# Groundwater Application Review Summary Form

Application # G- 18829 (re-review)

GW Reviewer Travis Brown Date Re-Review Completed: 3/15/2021

TO: Water Rights Section Date 3/15/2021  
 FROM: Groundwater Section Travis Brown  
 Reviewer's Name  
 SUBJECT: Application G- 18829 Supersedes review of 7/31/2019  
 Date of Review(s)

### Hydrographs

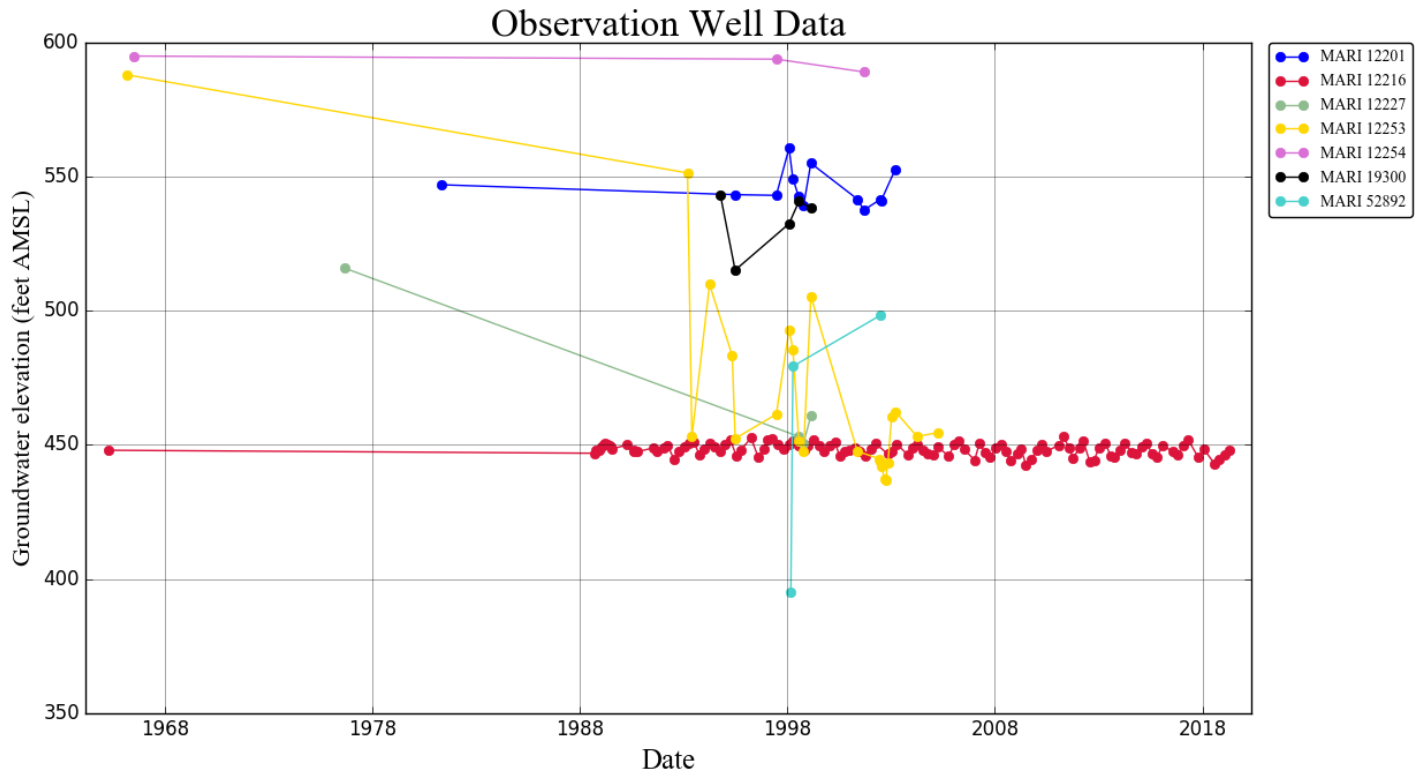
Long-term water level data are primarily available for wells located near or on the far side of normal faults mapped by Tolan and Beeson (2000). These data indicate varied water level trends, though most wells show only moderate water level declines over time (see attached Hydrograph). However, statistical analysis of water wells completed in Sections 20 and 21 of Township 8 South, Range 3 West indicate a trend of deepening well completions over time, as well as a trend of lower static water levels (SWLs) with deeper well completions (see Well Statistics – 8S/3W S20 & S21, attached). There is also some indication of deeper initial reported SWLs over time. These trends may be a consequence of dropping water levels in the aquifer. There is some uncertainty that the groundwater resource can sustain the proposed use of ~~0.17 cfs (-76 gpm)~~ 0.11 cfs (50 gpm); median reported well yield in Sections 20 and 21 is 20 gpm (~0.04 cfs), ~26 percent of the requested use (see Well Statistics - 8S/3W S20 & S21, attached). However, the maximum reported yield in these sections is 300 gpm (0.67 cfs).

**Theis Drawdown Analysis**

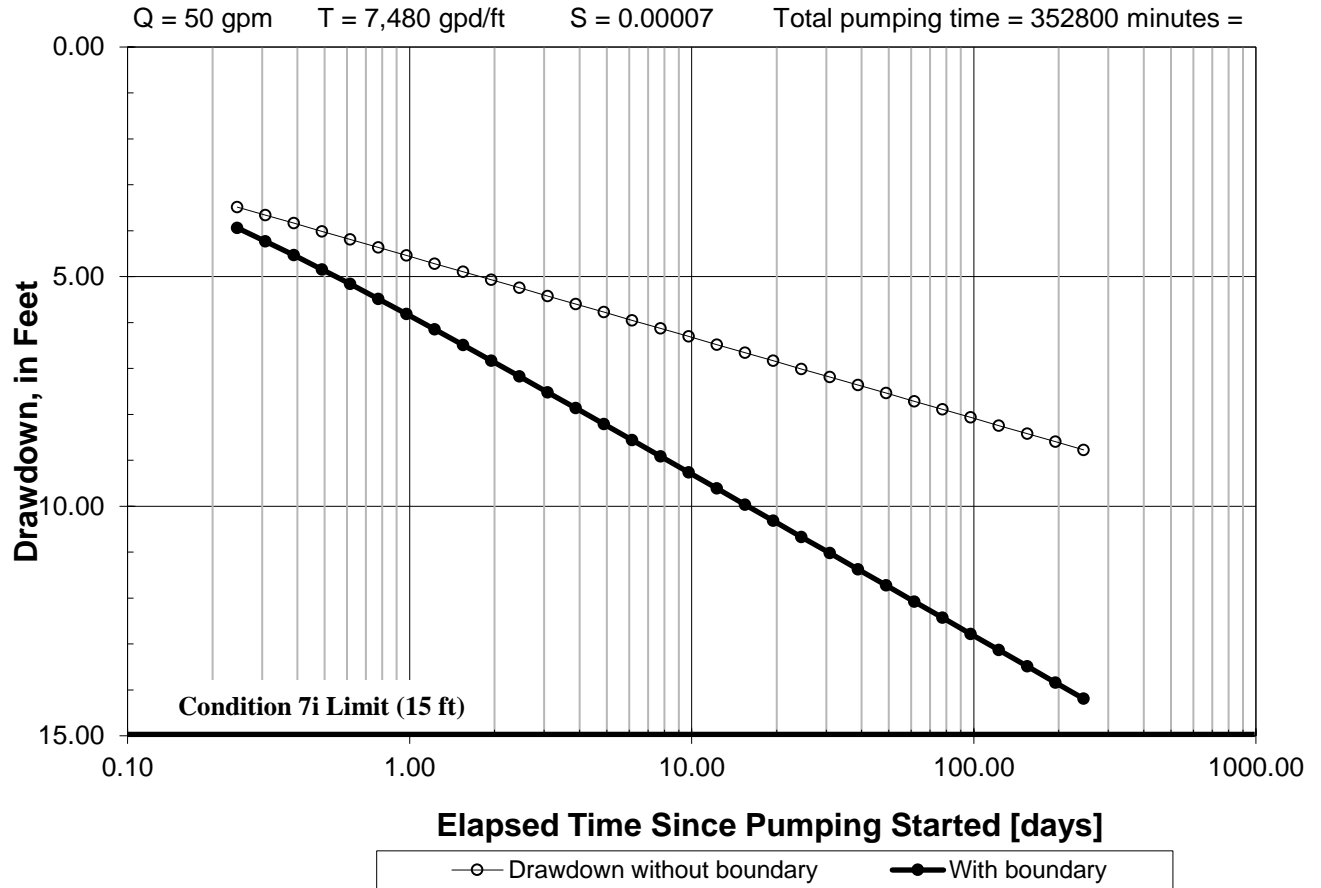
The nearest groundwater user (MARI 58051, an exempt domestic well) is ~290 ft northwest of the proposed POA location. **The location of MARI 58051 was not available at the time of approval for LL-1597.** MARI 58051 is completed to a depth of ~283 ft bls and has open annular space from ~151-283 ft bls. Although well construction information was not specified for the proposed POA, it is likely the proposed use would cause some degree of well-to-well interference with MARI 58051. To assess the degree of **drawdown interference**, a Theis drawdown analysis was conducted for the proposed use (see attached Theis Drawdown Analysis). ~~Results indicate that the proposed use could cause well-to-well interference with MARI 58051 to exceed 15 ft of drawdown within approximately 2 weeks of continuous operation, which would require curtailment of the proposed use per Condition 7i, above. Therefore, it would appear that groundwater for the proposed use will not likely be available in the amounts requested without injury to prior water rights.~~ **Results indicate that, at the revised requested rate of 50 gpm**

**(~0.11 cfs), the proposed use is unlikely to cause interference sufficient to deprive MARI 58051 or similarly-located wells of groundwater to which they are legally entitled.**
